1 Overview

Date of Notification	17 th September 2013
Component Affected	MONEx Part 11019 Throttle Sensor
Certified Part	12505
Customer Part	5520002123
Batch Affected	11019-1 to 11019-182 11019-184 11019-190 to 11019-193

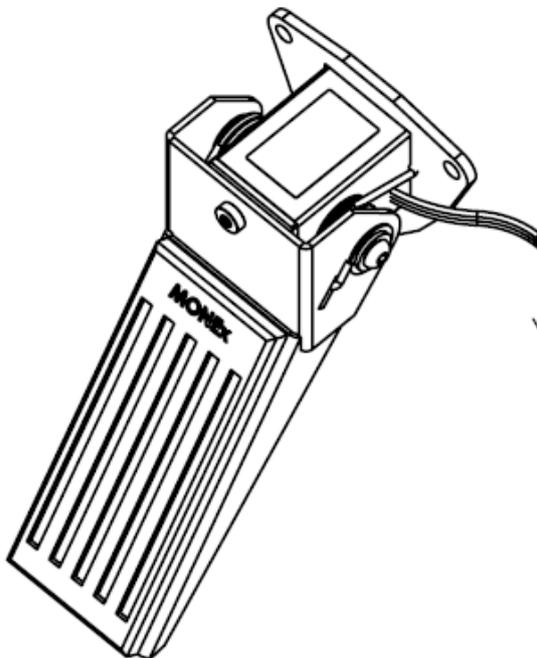
The throttle sensor is fitted with a double torsion return spring. The spring ensures the pedal returns to the idle position when released.

Evidence has been found of the spring cracking or breaking on one or both sides after various periods of operation in the field.

The double torsion spring is made from material which provides good corrosion resistance but has evidenced fatigue failure at the maximum stress points.

The spring cracks and break are consistent with those observed in returned throttles from the field. This confirmed the root cause as fatigue failure of the spring material.

A new spring material was finally selected which offered superior elastic properties in the required range with maintained corrosion resistance.

Further cycle tests were conducted for the new spring. Test completed with no sign of failure on duplex spring after 1,000,000 cycles.

1. Inspect all throttle sensors springs for cracks or breaks at next 2000 hour service. It should be noted that one side of the spring may fail and the throttle will remain functional. However, throttles should be returned for repair with any sign of spring crack or breakage.
2. Return any throttle sensor in the affected serial number range for spring replacement.
